**ENVIRONMENTAL PROTECTION AGENCY****40 CFR Part 52**

[EPA-R08-OAR-2010-0406; FRL-9648-3]

**Approval and Promulgation of Implementation Plans; North Dakota; Regional Haze State Implementation Plan; Federal Implementation Plan for Interstate Transport of Pollution Affecting Visibility and Regional Haze****AGENCY:** Environmental Protection Agency (EPA).**ACTION:** Final rule.

Figure 1. Coal-Fired Boilers Operating Below 0.17 lb/MMBtu

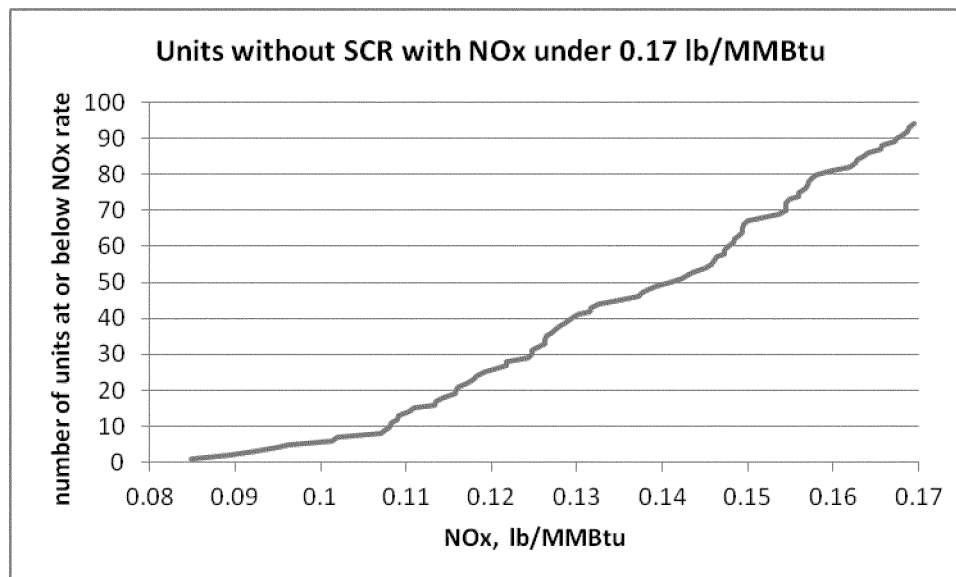
Analysis of emissions data found significant discrepancies in Figures 2.2 and 2.3 of GRE's November 2011 Refined Analysis. A review of EPA Title IV data for 2010 showed 94 coal-fired boilers that do not have SCR achieve annual emissions levels below 0.17 lb/MMBtu, with the median slightly under 0.14 lb/MMBtu (see Figure 1 below). Of these, ten of them are using SNCR in combination with combustion controls to achieve under 0.17 lb/MMBtu. See docket for a list of these facilities. Of these ten, three are supercritical tangentially-fired boilers that use lignite coal with emissions below 0.14 lb/MMBtu. These include Big Brown 1 and Monticello 1 and 2, as discussed earlier in our responses. In addition, the NEEDS Database v.4.10 for the Final Transport Rule in the CSAPR docket includes two tangentially-fired coal/steam units from North Carolina with LNC3 and SNCR that had emission rates of 0.159 lb/MMBtu and 0.164 lb/MMBtu.

As we explain elsewhere, we have decided to revise the BART limit from 0.12 lb/MMBtu to 0.13 lb/MMBtu on a 30-day rolling average.
